SITE MANAGEMENT TEAM MONTHLY CALL SUMMARY
FORMER DEFENSE DEPOT MEMPHIS, TENNESSEE
14 JUNE 2022
11:00 EDT

Offsite Groundwater Investigation

Figure 12
Memphis Aquifer
Groundwater Elevations -
October 2021
 Annual Long-Term
 Monitoring Report 2021
 Defense Depot
 Memphis, Tennessee

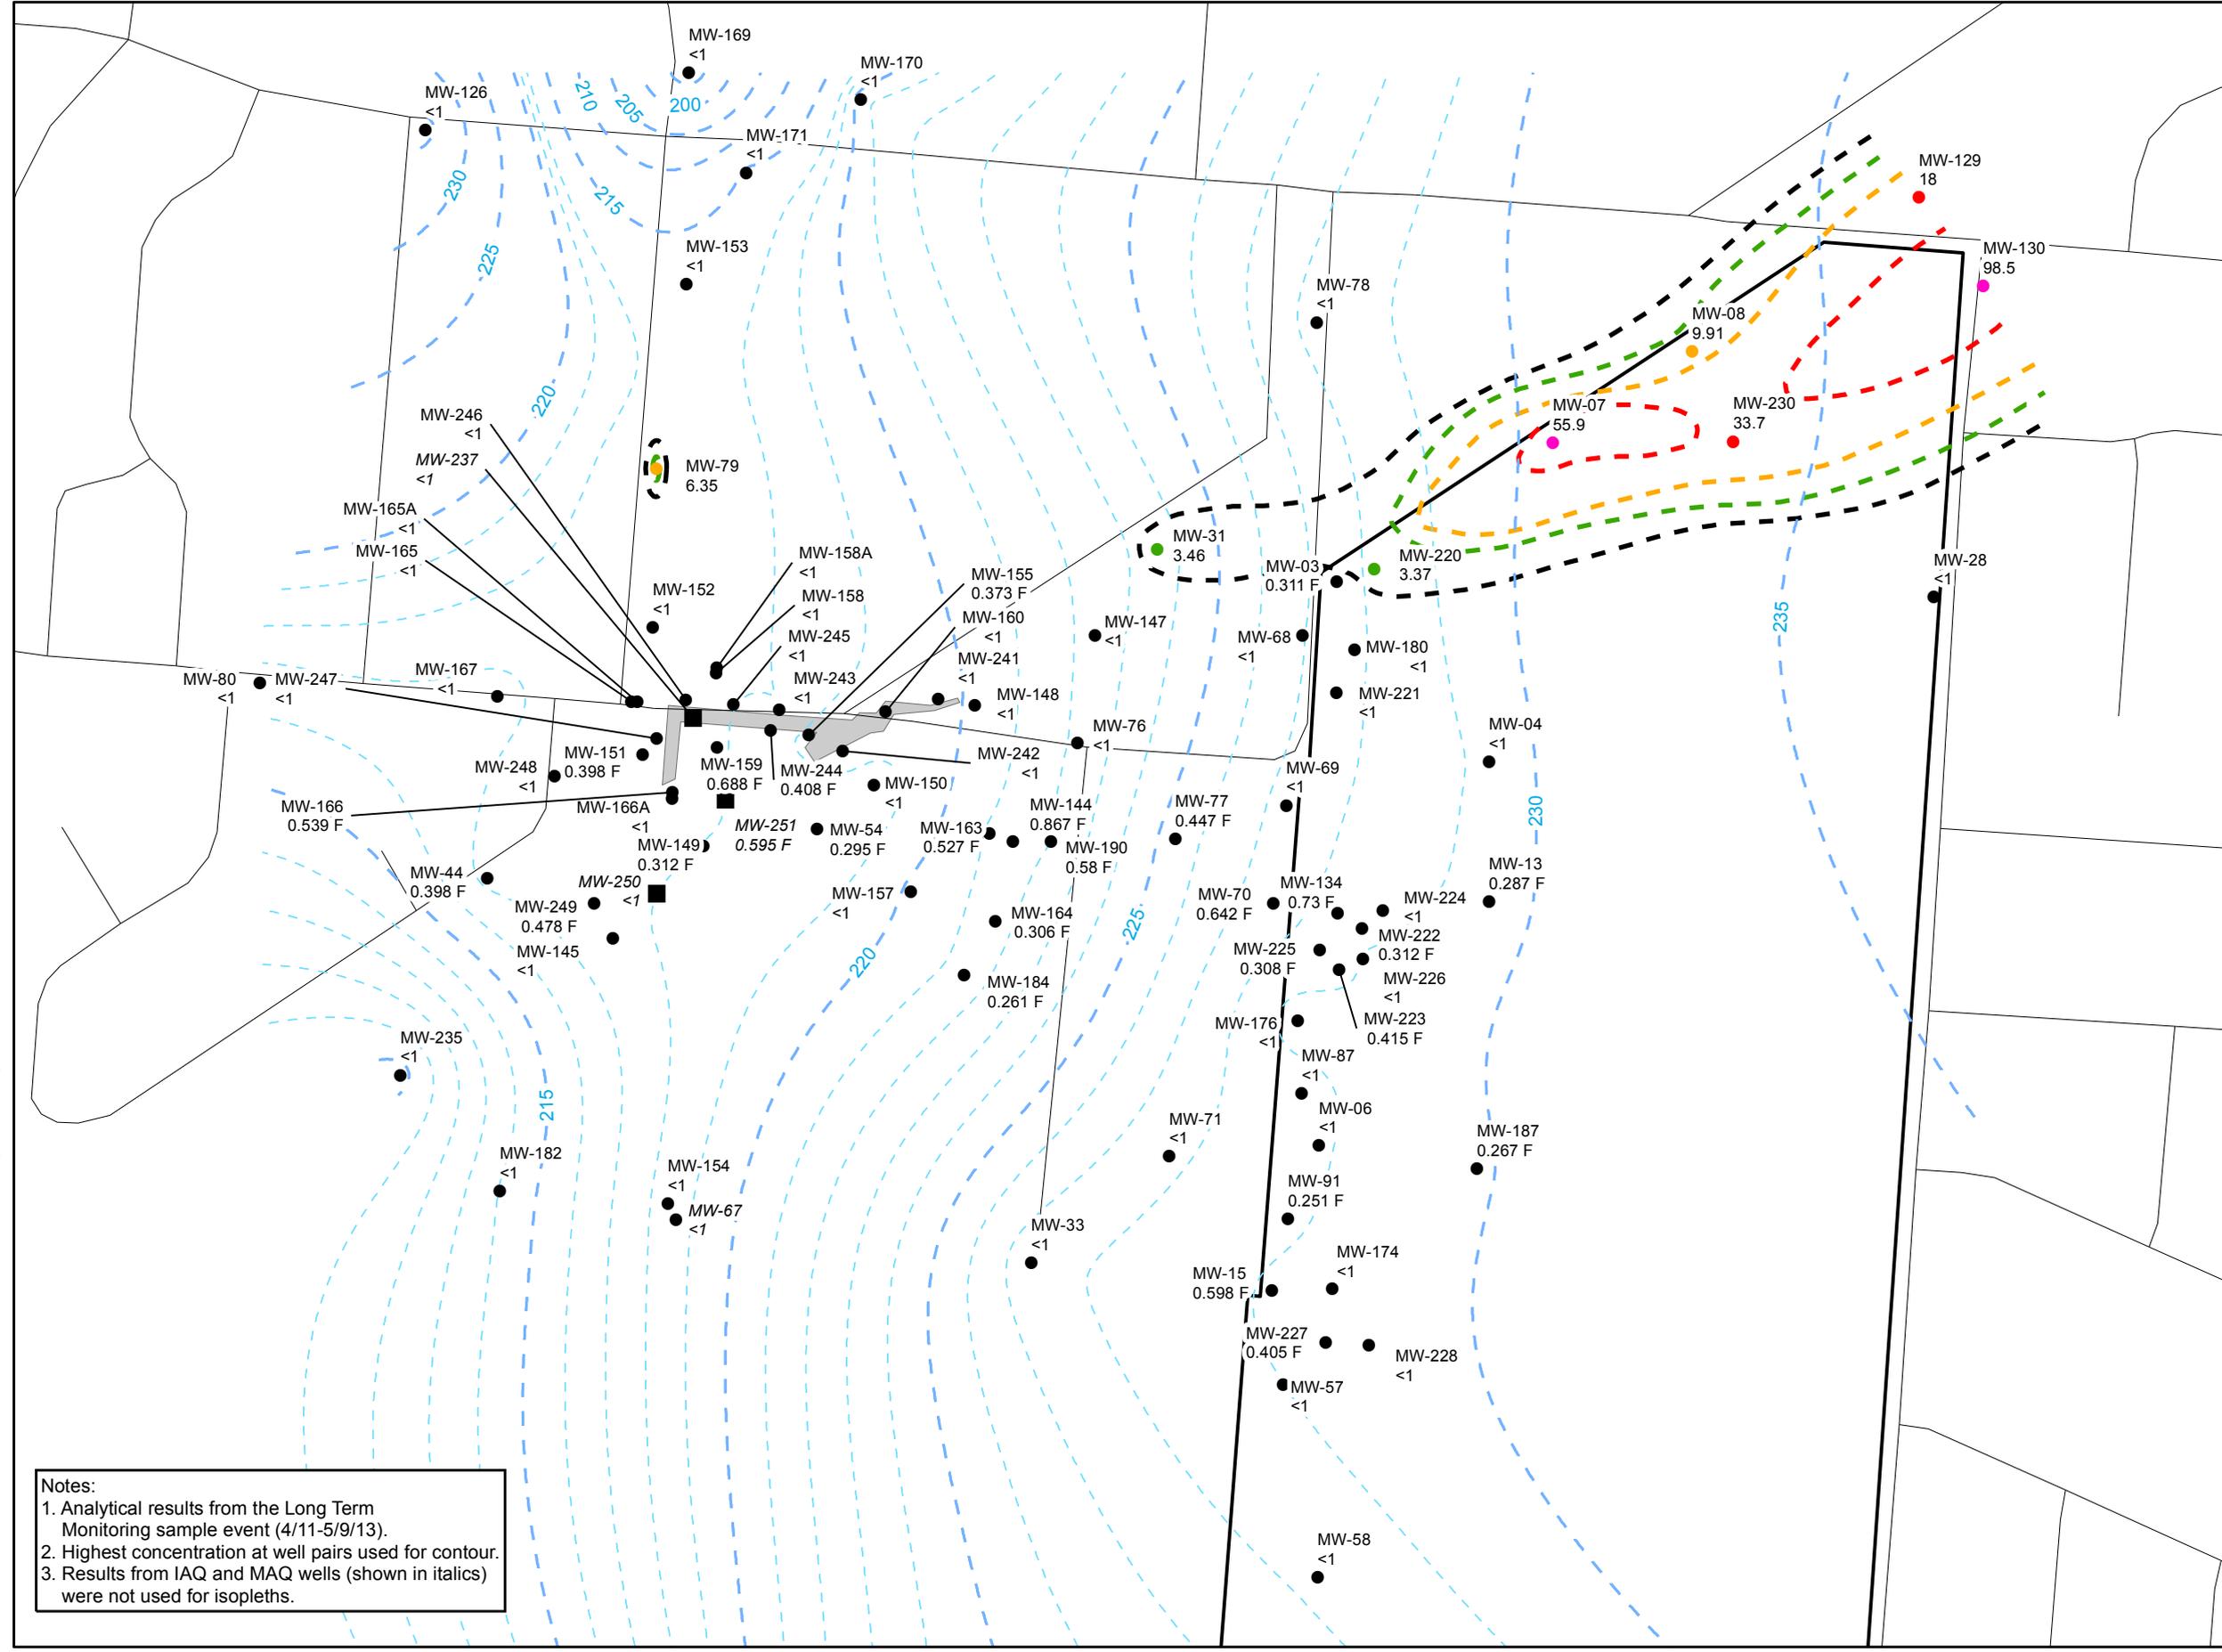
Mr. Holmes said that a second comment was whether contaminated groundwater may be drawn into the Memphis Aquifer within the drawdown area of Allen Well Field, which is located 1-2 miles west of Dunn Field. He stated vertical migration of groundwater contaminants would be indicated by groundwater flow contours and shared the October 2021 DDMT groundwater contour map for the Fluvial Deposits Aquifer (FDAQ). The groundwater flow direction for the Offsite plume on Dunn Field is west-southwest to a trough in the groundwater surface (225 feet elevation) about 1,000 feet west of Dunn Field, at which point groundwater flows to the north. There are no closed contours in the area of the plume indicating vertical leakage. He noted that the Intermediate Aquifer (IAQ) groundwater elevation at the trough is at 176 feet, approximately 50 feet lower than the Fluvial Deposits Aquifer.

Figure 34
DUNN FIELD
PCE
CONCENTRATIONS,
APRIL 2013
 ANNUAL LONG
 TERM MONITORING
 REPORT - 2013
 DEFENSE DEPOT
 MEMPHIS, TENNESSEE

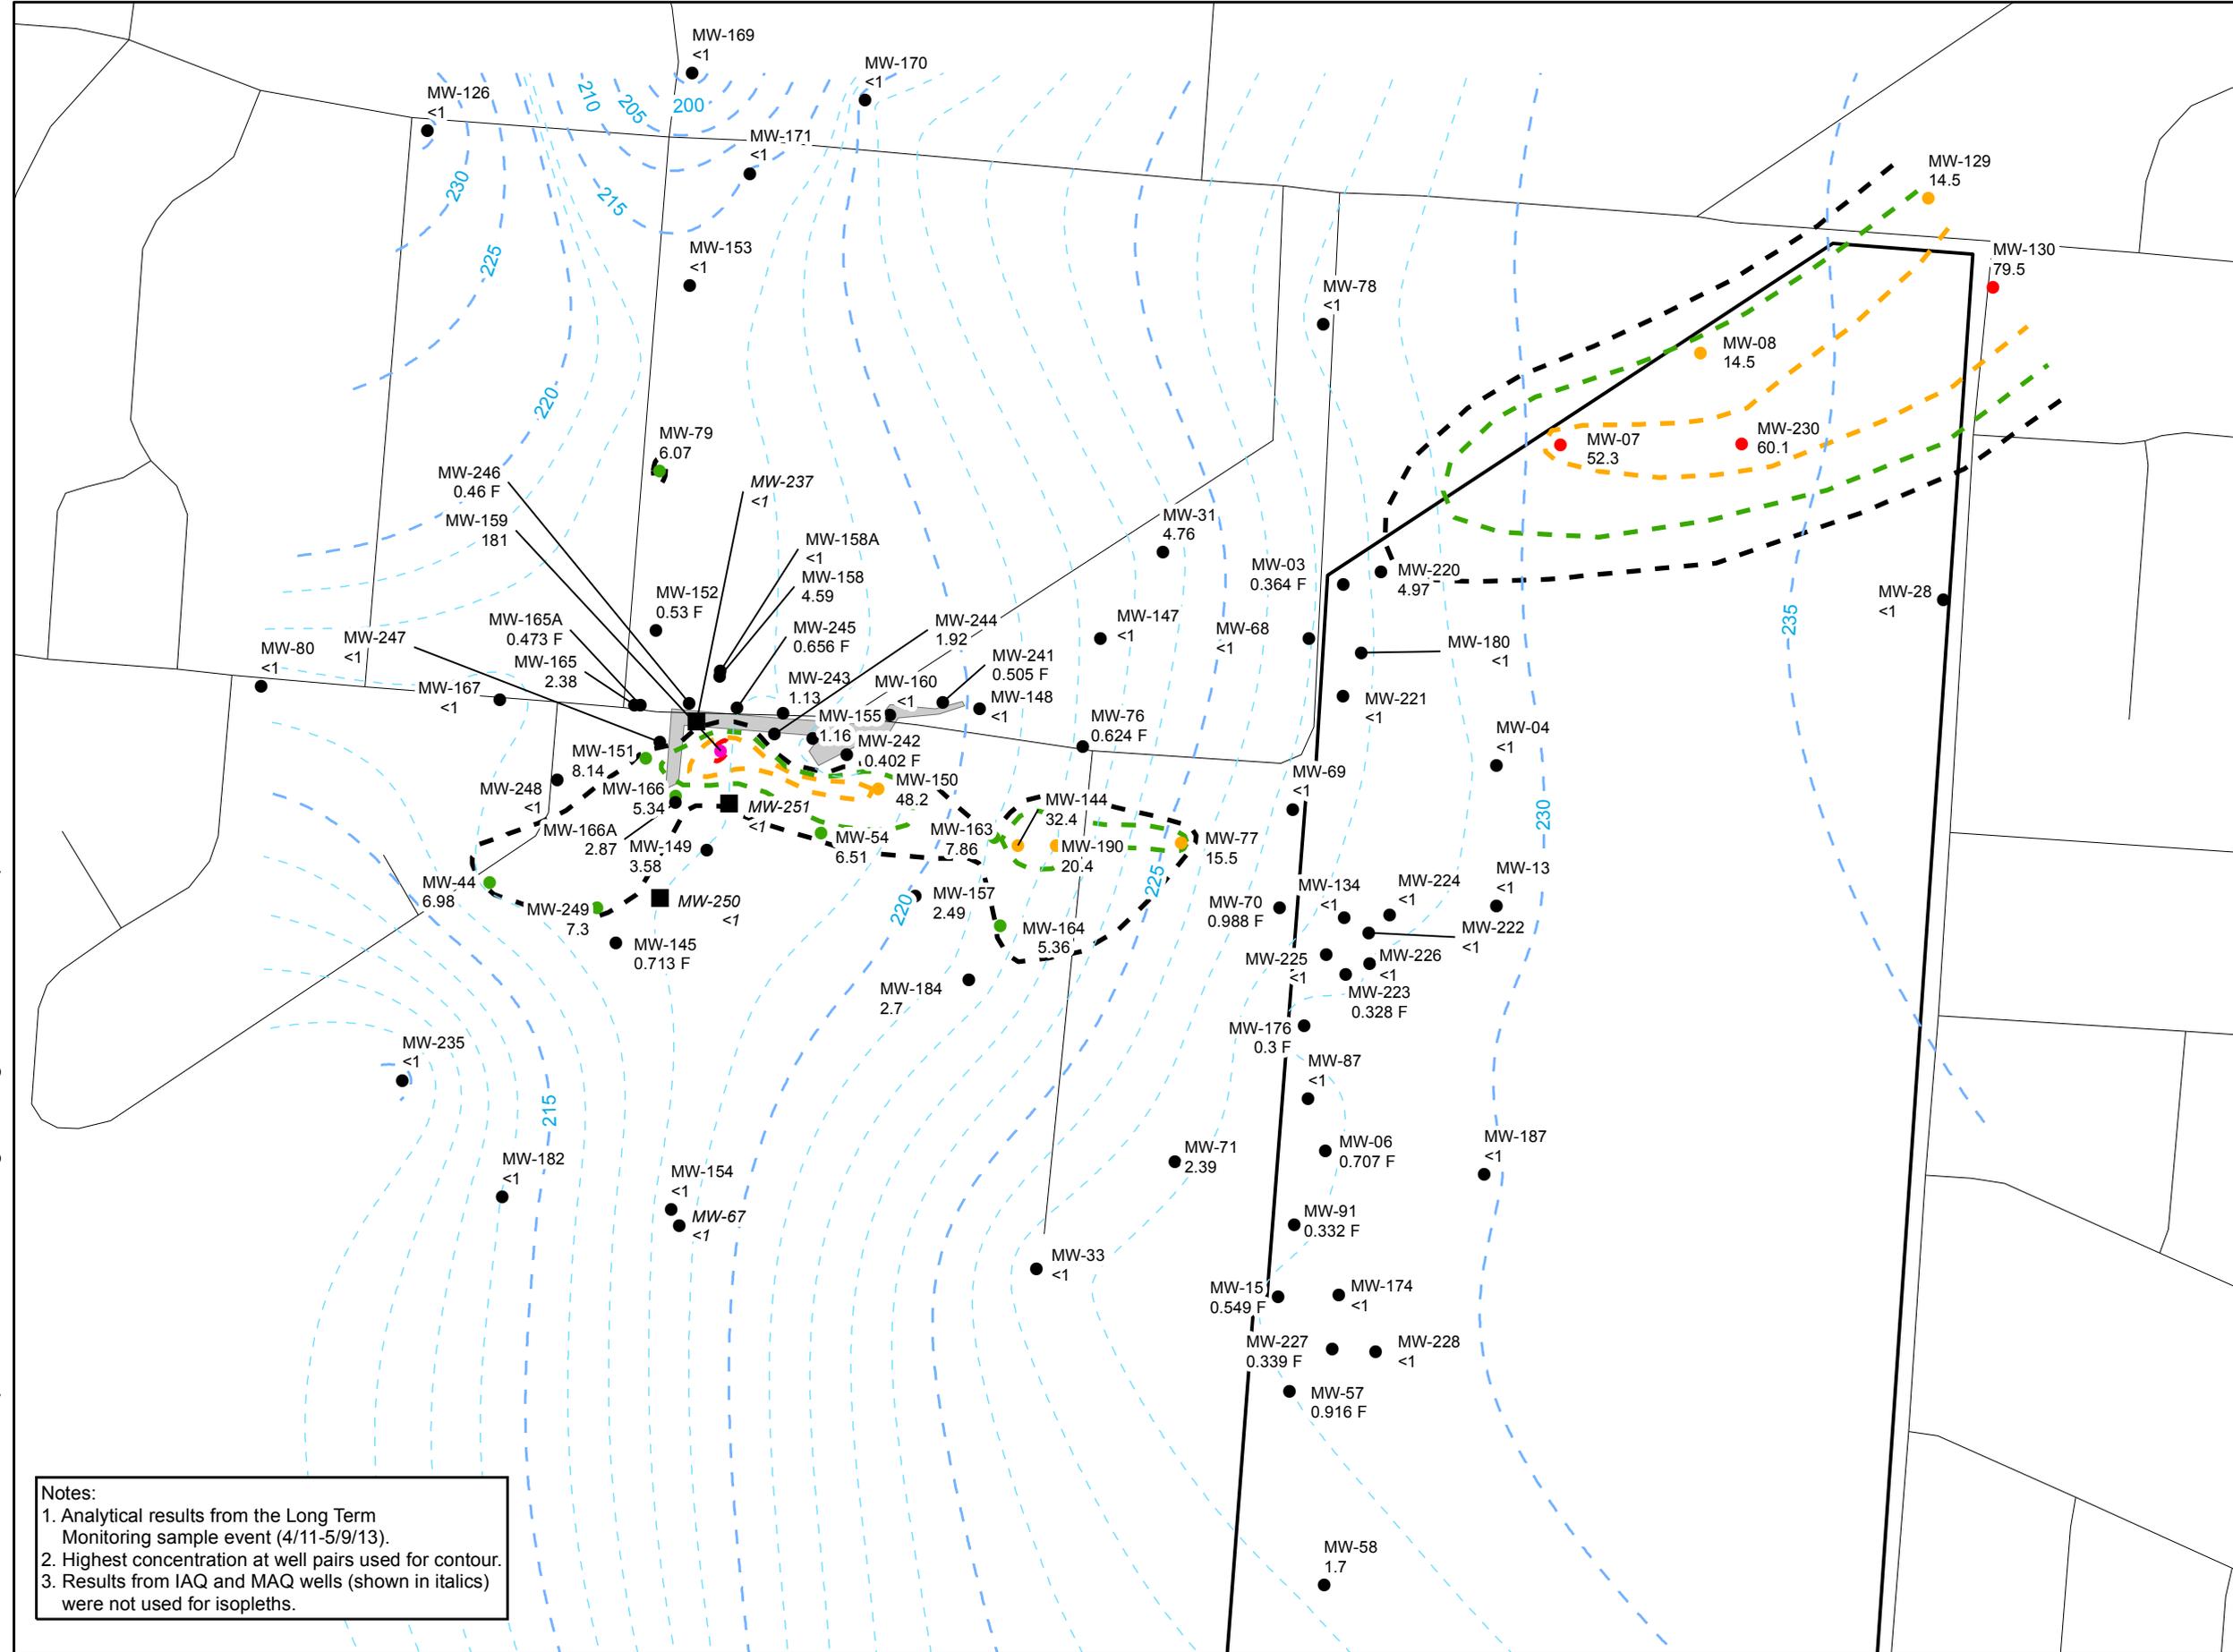
Mr. Holmes said he would like to discuss the comment about OSI plume extent. The OSI report asserts that the plume does not extend past MW-79. Figures from the 2013 and 2019 LTM reports show the plume terminating near MW-79 were shared. PCE and TCE concentrations were slightly above the MCL at MW-79 with non-detect results downgradient (south). The plume does not extend into an area of vertical leakage window where it could reach the Memphis Aquifer. The plume is mainly impacting commercial property, except for the residential area in the upgradient portion of the plume.
